SUBJECT: Forwards responses to NRC Allegations 1430 & 1431 re pipe supports raised during 850114-17 piping audit. Based on analysis results, location or type of support precluded as cause for overstress.

PGandE Letter No.: DCL-85-041

Re: Docket No. 50-275, OL-DPR-80
Docket No. 50-323
Diablo Canyon Units 1 and 2
NRC Allegations 1430, 1431, and 1432

ENCLOSURE

Heatup Walkdown Problem Report

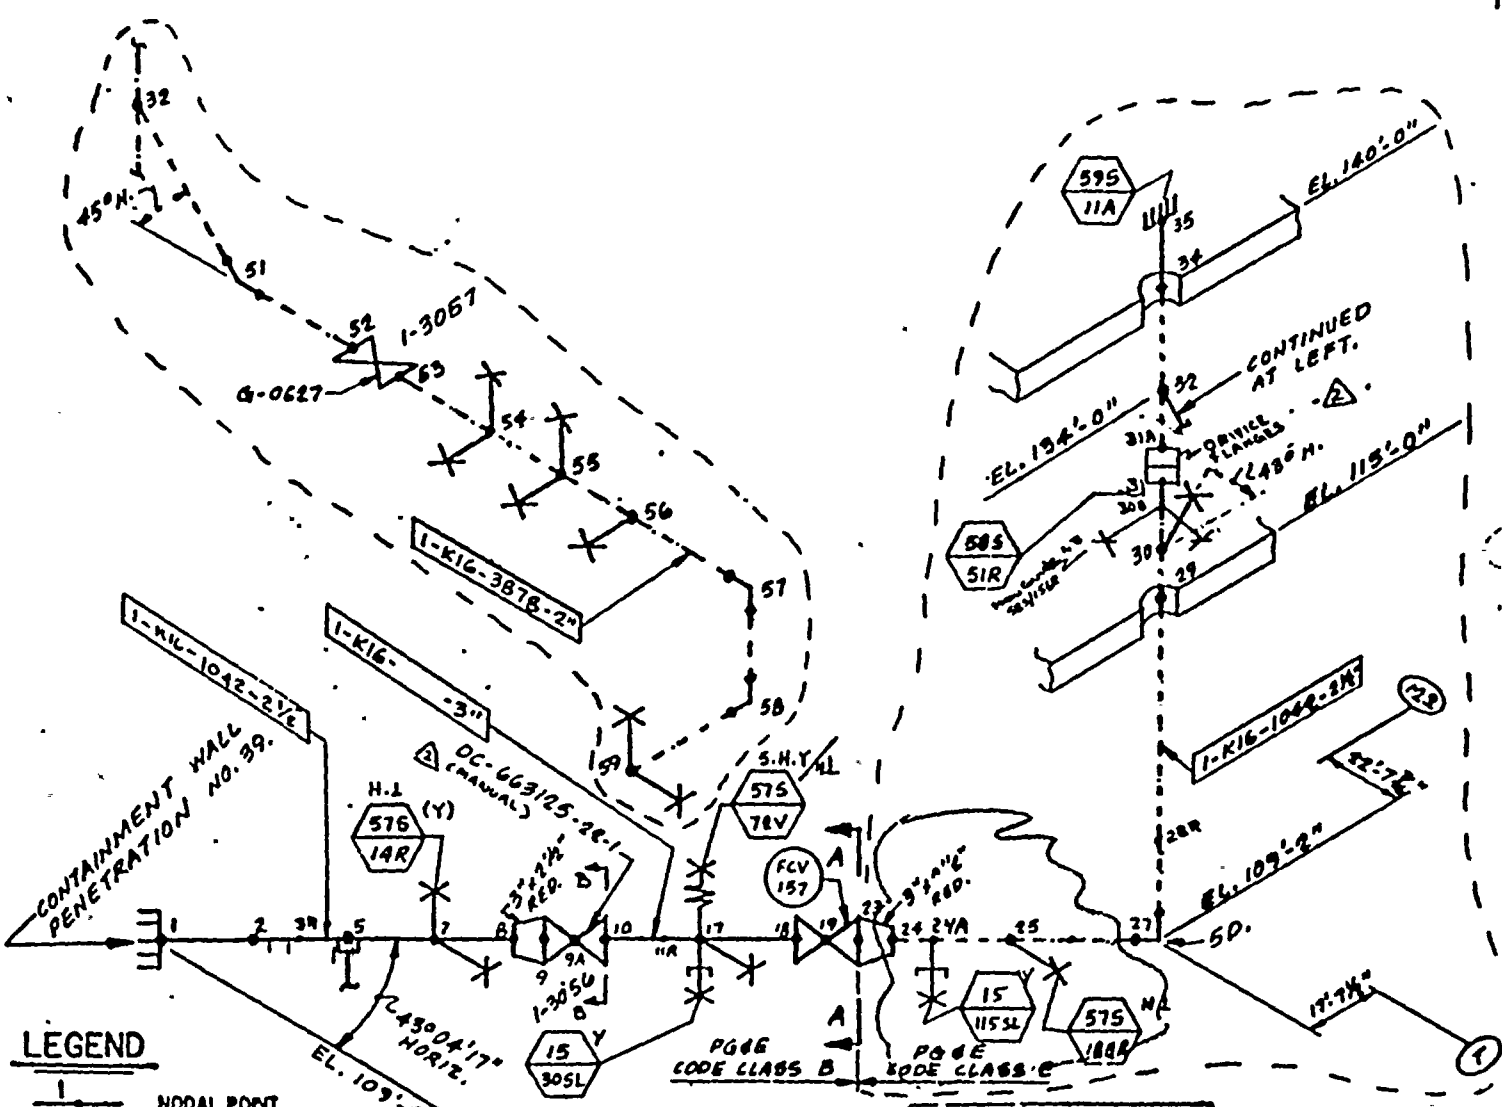
Describe Problem: PIPE CLAMP ON 15-115 SL IS UP AGAINST STEEL
OF ADJACENT HANGER S75-188R, CAUSING AN UNINTENTIONAL AXIAL
RESTRAINT. THE CALCULATED MOVEMENT IS 1.6" AXIALLY.
CLAMP SHOULD BE RELOCATED 1 3/4" N.W. TO ALLOW THIS MOVEMENT.
(REMOVE INSULATION FIRST TO DETERMINE IF PIPE CONFIGURATION WILL
ALLOW MOVING CLAMP) (.80" NORMAL, .88" DILATION, 1.60" ACCIDENT
WITH DILATION) RHN '2-3-84

Resolution: Move clamp on 115 SL 5" downstream to other
side of 188R. KAP 2-10-84 REDESIGNS FOR ABOVE SUPPORTS
ISSUED TO RESOLVE INTERFERENCE. ISSUE DATE 2-10-84
PER DCI-EP-17476 RO

SUBJECT _____

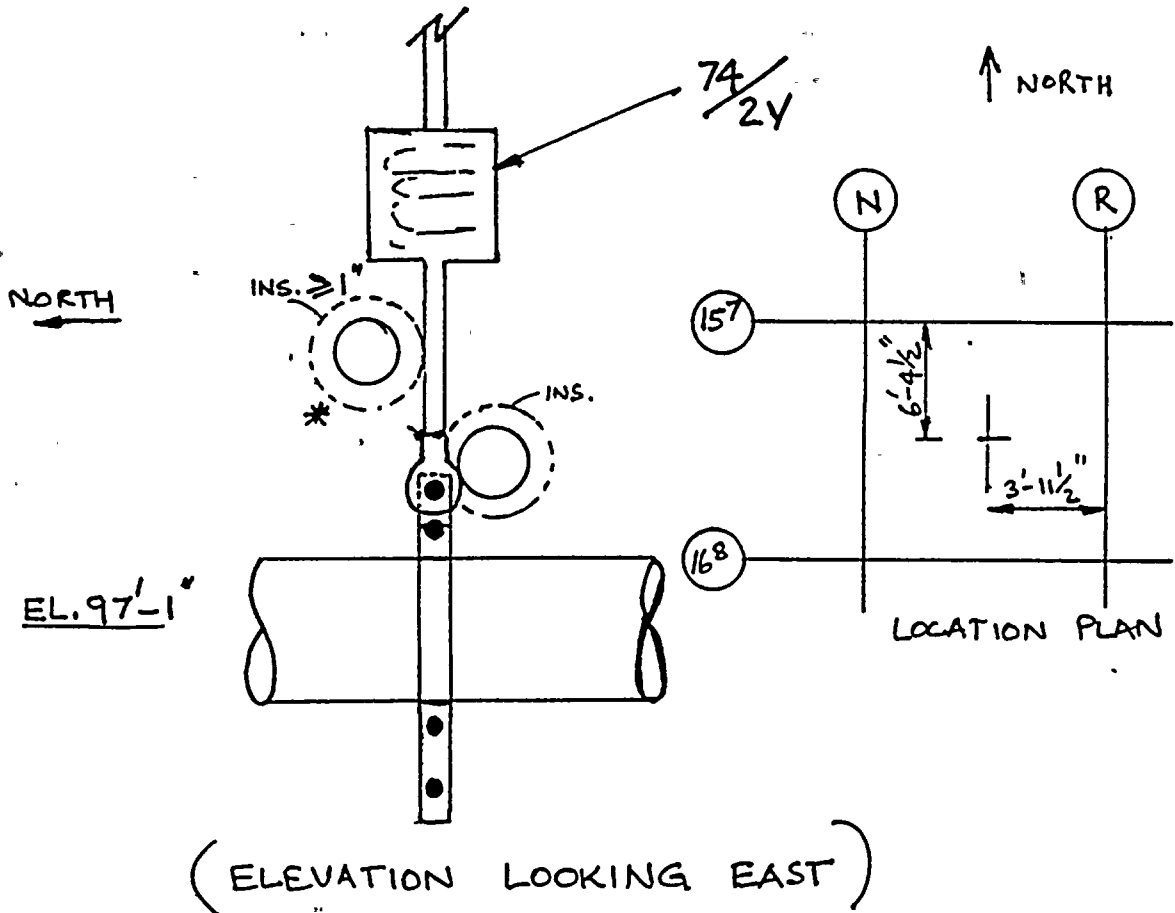
* CUT INSULATION AND MOVE ROD HANGER (CLAMP) $\frac{1}{2}$ ' NORTH
ON UPPER 1" ϕ LINE

STRESS WALKDOWN PROBLEM REPORT

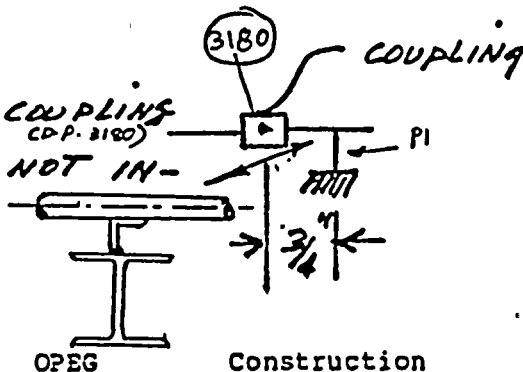
2-2" interference exist between coupling & D.L.S. RESTRAINT. ALSO DLS RESTRAINT IS NOT INDICATED ON ISOMETRIC.

SFHO TO EVALUATE THE D.L. SUPPORT AND UNINTENTIONAL AXIAL RESTRAINT IN N-W DIRECTION.

Predicted displacements are .15" (HFT), 1.07" (Normal), 2.5" (Accident), all in direction of DLS. DLS is not in analysis. Delate DLS. *7/1/84*
